SERVICE BULLETIN

SB1271

ADDRESSEES	: ABC Customer Care and Parts Source Owners and operators of coaches listed under "Application"
VEHICLE MODEL	: CX45 with Detroit Diesel engine
MANUAL SECTION	: 8.14 Climate control – refrigerant system
BULLETIN TYPE	: Field Change Program
DATE	: October 28th, 2014
SUBJECT	: To replace A/C compressor discharge hose
TERMS & CONDITIONS	: Refer to the warranty section further in this Bulletin.

Figure 1

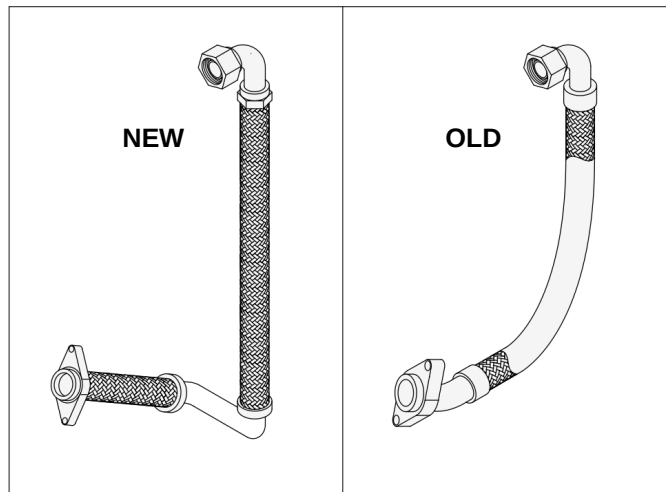
- Field reports have determined that there is a frequent failure of the A/C compressor discharge hose.
- To address this issue, Van Hool is conducting a Field Change Program, the terms and conditions of which are explained further on under "Warranty".
- Owners and operators of the affected units should follow the procedure below to replace the A/C compressor discharge hose.
- The procedures in this Bulletin provide the necessary fitting instructions.

VH Reference	Description	Qty.
11332854	A/C compressor discharge hose	1

VH Reference	Description	Qty.
11419554	A/C compressor discharge hose (with O-ring included)	1
11133042	Gasket	1

Step	Action
1	Remove and discard the old discharge hose.
2	Connect the new discharge hose.
